WorldSID-50M Material Update to GTR IWG

March 2, 2011

ILIAC WING MATERIAL CHANGE

Iliac Wing Material Change

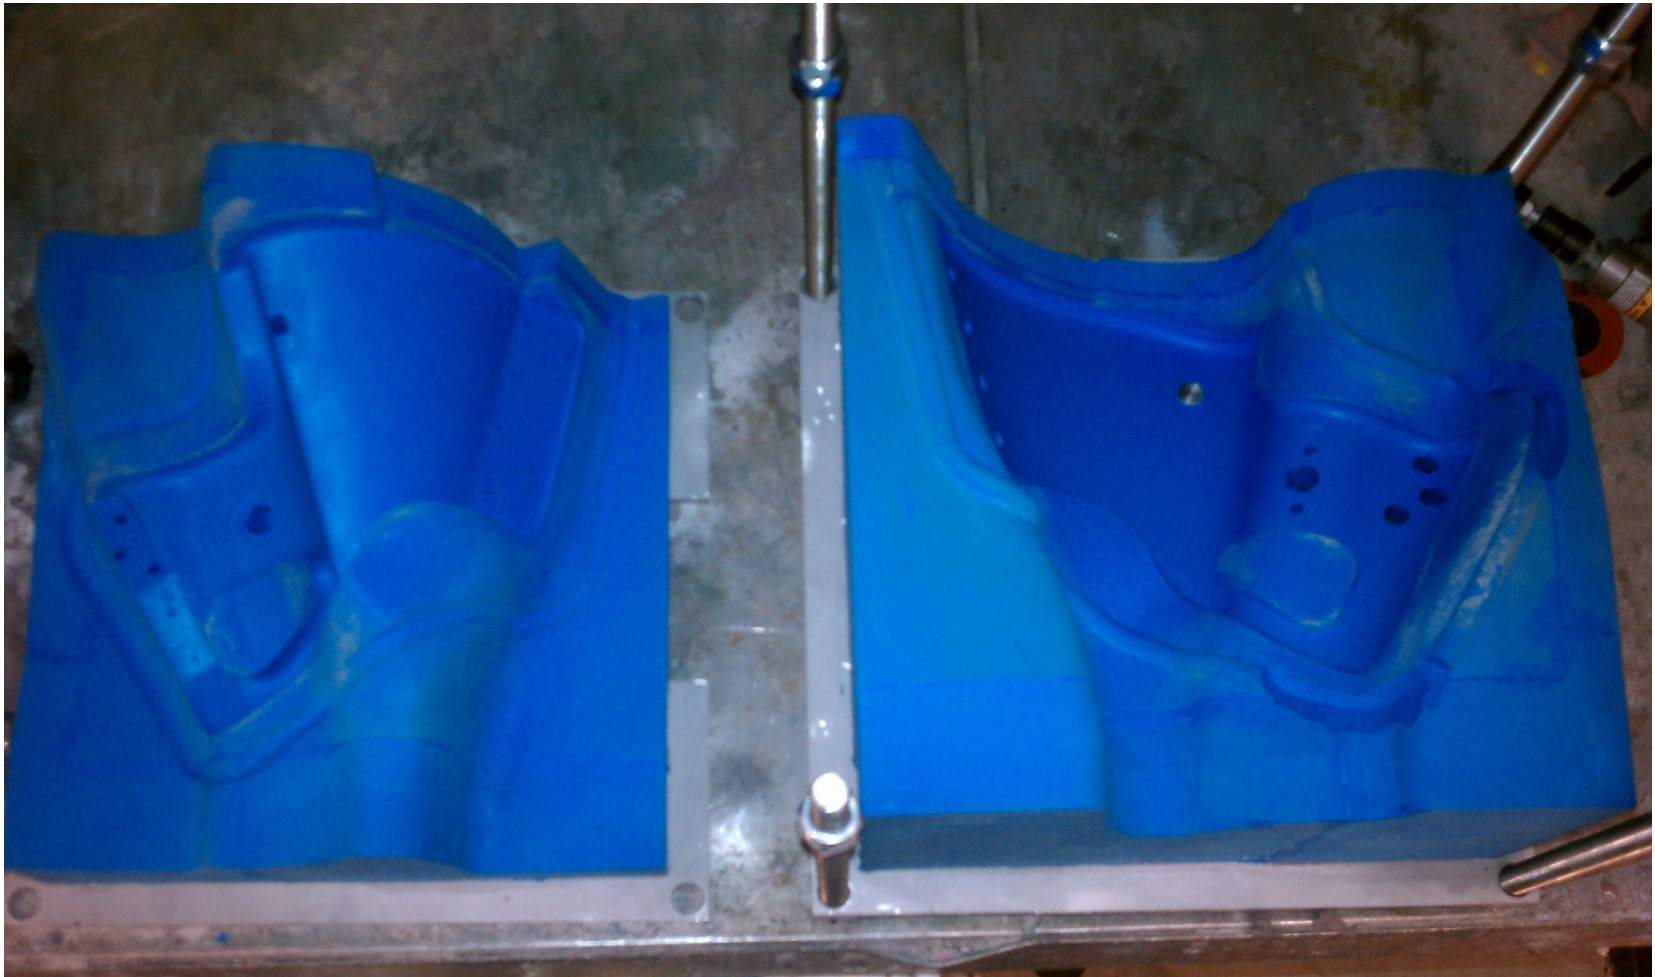
- Ureol material no longer available
- Will run out in coming months

- Design & build new mold
- Develop equivalent material
 - ▶ Develop process with new material
 - ▶ Match Ureol at material sample level
 - ▶ Static & Dynamic component level tests
- Final verifications
 - ▶ Dummy certification tests
 - ▶ Dummy pendulum biofidelity tests
 - ▶ WorldSID task group trials
